UNITED STATES
DEPARTMENT OF THE INTERIOR
BUREAU OF LAND MANAGEMENT

FORM APPROVED
OMB NO. 1004-0135
Expires: July 31, 2010**SUNDRY NOTICES AND REPORTS ON WELLS**
Do not use this form for proposals to drill or to re-enter an abandoned well. Use form 3160-3 (APD) for such proposals.

1. Type of Well <input checked="" type="checkbox"/> Oil Well <input type="checkbox"/> Gas Well <input type="checkbox"/> Other		8. Well Name and No. ALLIED 93 05
2. Name of Operator DUGAN PRODUCTION CORPORATION		9. API Well No. 30-025-24901-00-S1
3a. Address FARMINGTON, NM 87499	3b. Phone No. (include area code) Ph: 505-325-1821	10. Field and Pool, or Exploratory SAWYER
4. Location of Well (Footage, Sec., T., R., M., or Survey Description) Sec 24 T9S R37E SENW 1980FNL 1980FWL		11. County or Parish, and State LEA COUNTY, NM

Permanent Abandonment of Federal Wells
Conditions of Approval (LPC Habitat)

Allied 93 # 5, San Andres

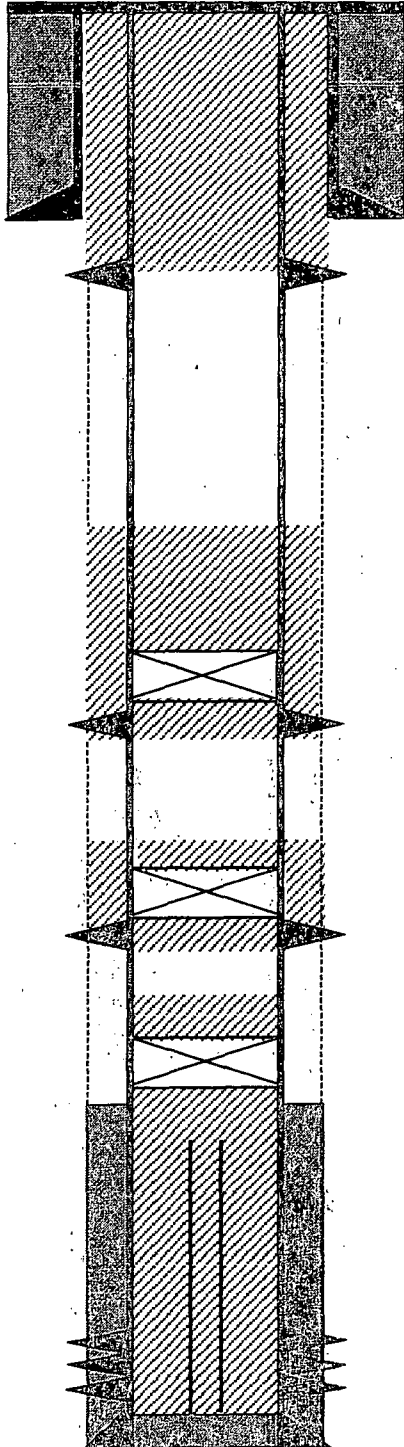
SQZ w/ PKR 2990-28
SQZ w/ PKR 2450-23**SEE ATTACHED FOR
CONDITIONS OF APPROVAL***Below ground dry hole marker required*

**** BLM REVISED ** BLM REVISED ** BLM REVISED ** BLM REVISED ** BLM REVISED *****MSB/OCD 12/15/2014*
